Chapel Walks (Cavendish House)
Design and Access Statement Addendum

March 2021
Job 1814

Addendum Revisions

Design development – indicating the altered shape and position of the new columns to suit the existing structural grid.

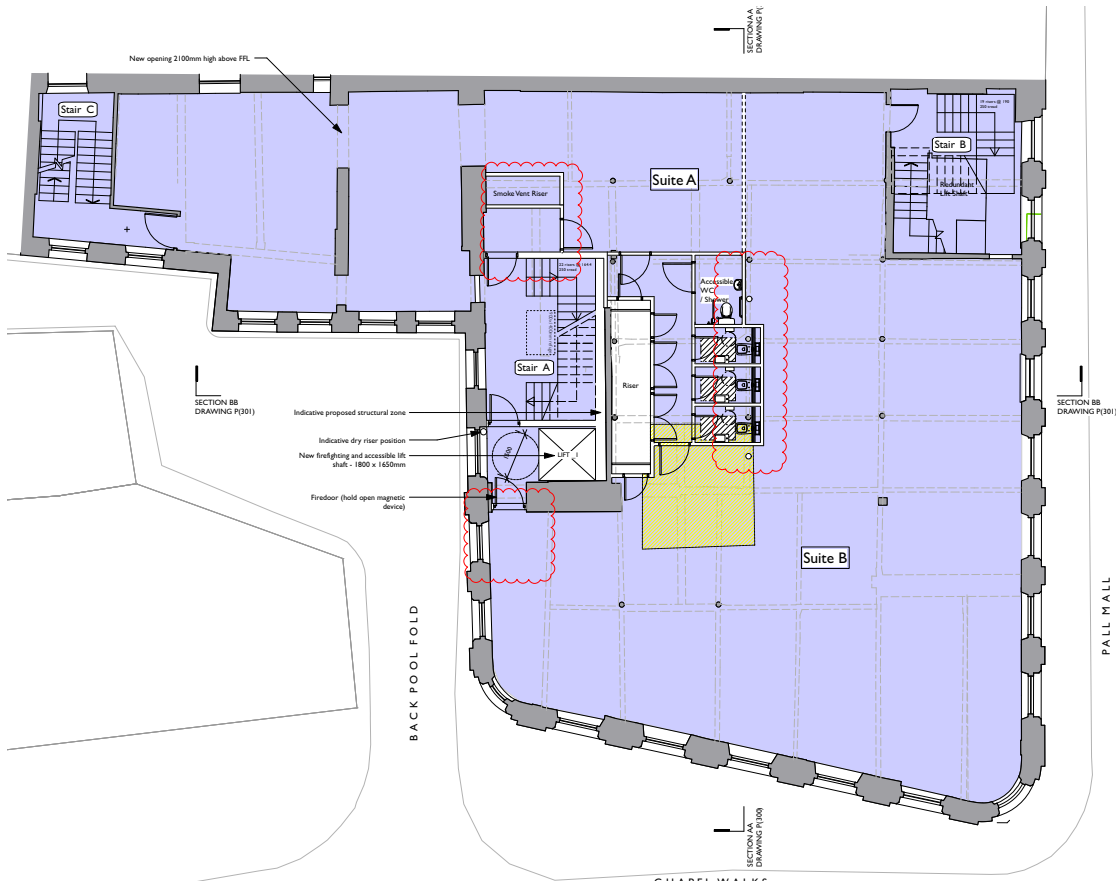
As part of the detailed design phase of this scheme, the team have been considering the necessity of revisions to the structure and, consequently, have identified the need to include 2 no. additional columns through the building to reduce the size of the main cross beams.

“Although the original scheme was feasible from an engineering perspective, due to site constraints the scheme presented some risks to the original fabric as all additional loads were to be carried by the existing walls. Upon further development of the design it was deemed prudent to introduce two columns which would carry much of the additional load. This solution also presents other benefits to the scheme with regard to transportation of materials (smaller vehicles required for delivery and likely fewer total vehicle movements) and craneage of materials (a smaller crane is likely) which are particularly pertinent for city-centre sites with difficult site access, such as in this case.”

The columns have been designed and positioned so as to mitigate their visual and physical impact. They are designed as Circular Hollow Sections – similar in size and shape to the existing columns within the space. They have also been positioned to tie into the existing structural grid.

At 1st floor, the lower of these columns occurs in the part of the floor currently occupied by a non original staircase. Therefore this column will be integrated into the replacement floor as per the extant Listed Building Consent.

The new WCs proposed at the upper floors, have been modified slightly to suit the positions of these new columns. This change has also resulted in another of the historic columns becoming exposed within the main office space, whilst all other columns remain exposed within the WC cubicles themselves.

Revised WC layout results in an additional historical column exposed within the office. Yellow square indicates new floor infill to existing non-original staircase.

Revised ground floor plan indicating shower and cycling facilities to the rear.

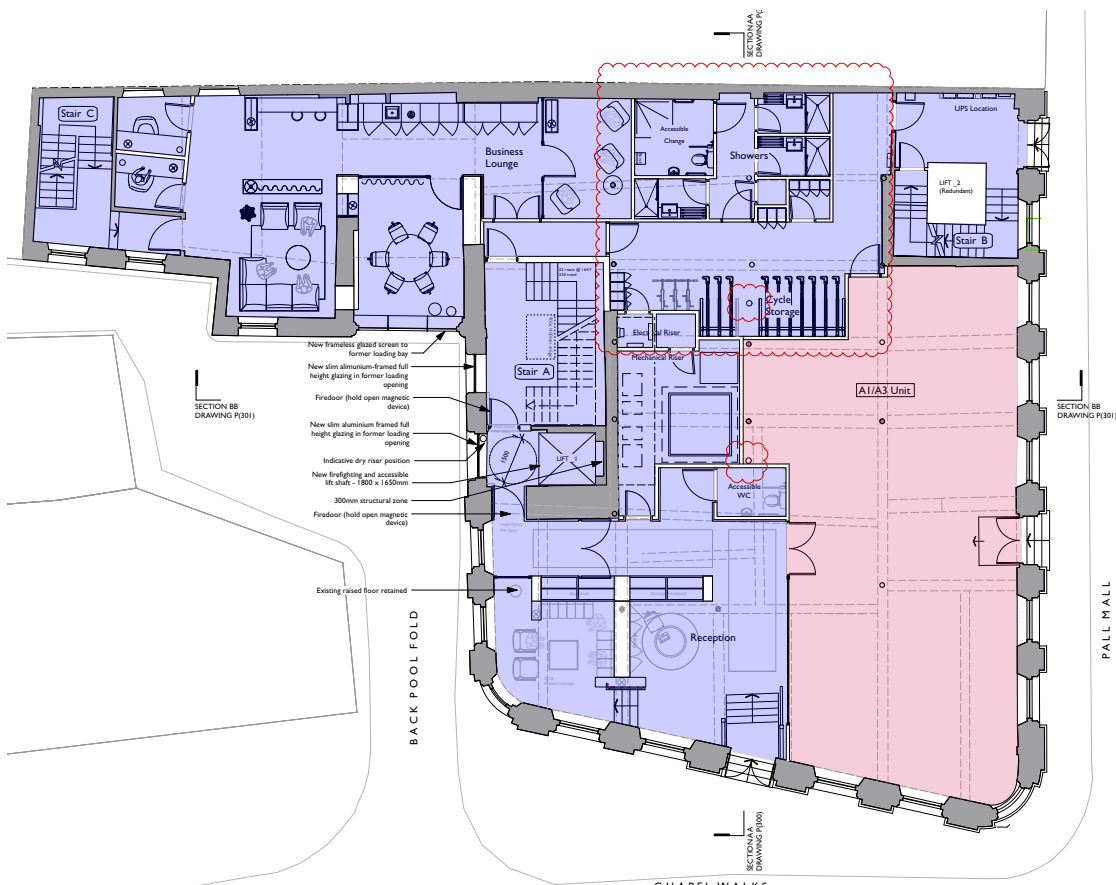
At ground floor, showers and cycle storage have been added into the scheme. These occupy some of the space previously given over to an AI unit, and form a natural extension to the Business Lounge area already proposed. Since the previous design was prepared, the market has changed. Please see below commentary on this issue from the developer:

The new shower facilities will be enclosed in lightweight metal stud partitions, and the layout has been designed such that all columns remain exposed. The area is currently occupied by part of the former restaurant dining area. The nature of the contemporary fit-out to the space ensures there is no evidence of historical detailing remaining.

“Following detailed design development of the scheme it became clear the building required a larger colder water tank and booster set along with suitable space for maintenance. This has led to a design adjustment in order to provide suitable floor area for this plant.”
